Re: St. Paul's School – Admission Center (PL-AMEND-2025-0015)
16 Dunbarton Rd. (325 Pleasant St.)
Map 723Z Lot 13-1

Below is a detailed timeline of the St. Paul's School Admission Center Project located at 16 Dunbarton Road, as requested in support of the Site Plan Amendment Application.

J - PL-AMEND-2025-0015 Application

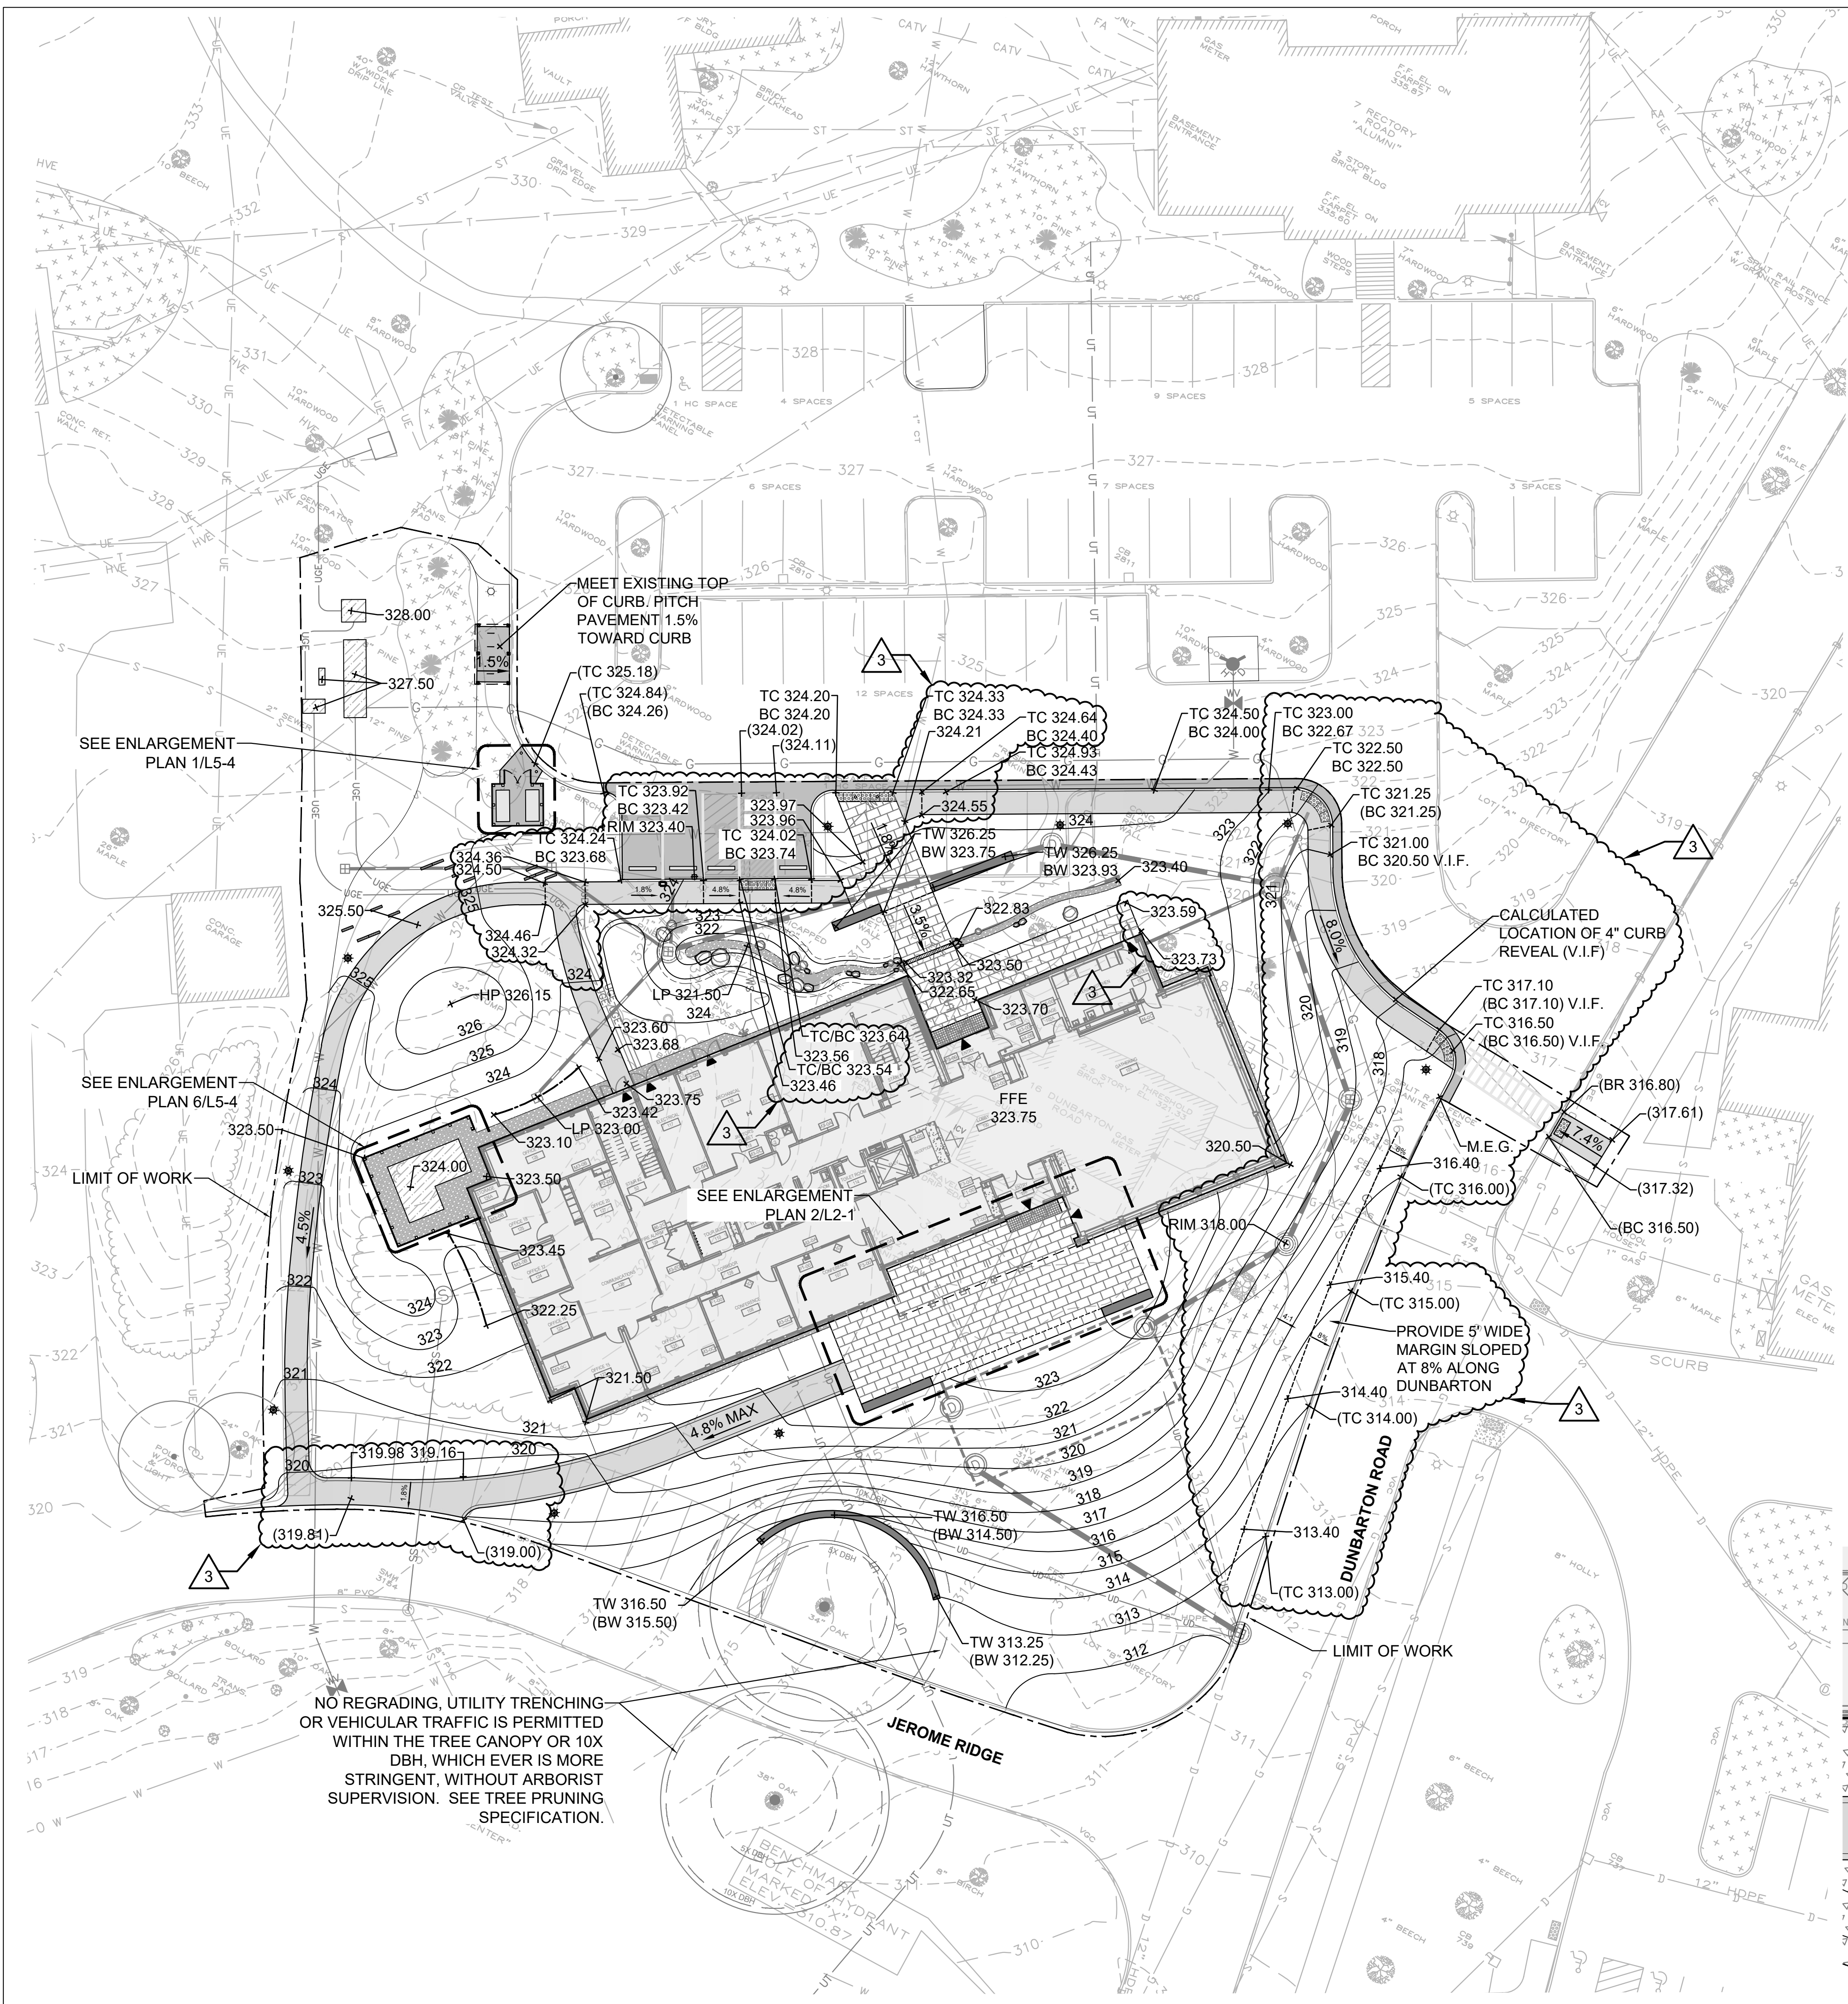
Sheet L2-1 needs to be revised and submitted again for review before I can approve the administrative approval PL-ADM-2025-0078. The sheet with comments is in the portal, and the comments are also added to the comments for "requires re-submit."
